**Service Letter No. 416  
December, 1994**

**SUBJECT: New Slave Piston Removal Tool**

**MODELS AFFECTED: All, Especially 340 and 340A**

**Slave Piston Removal Tool  
P/N 018238**

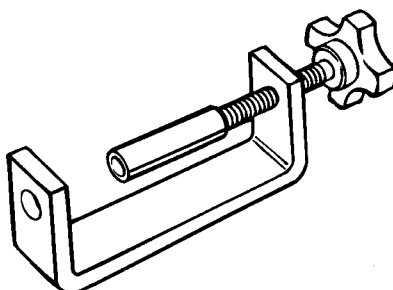
Jacobs has released a new Slave Piston Removal Tool, P/N 018238, for the Models 340 and 340A engine retarder. The inner diameter of the sleeve on this tool is larger than the sleeve inner diameter on the Slave Piston Removal Tool, P/N 017397, in order to fit over the Model 340A slave piston foot. The new tool, P/N 018238, will fit other current model engine retarders as well as the Models 340 and 340A.
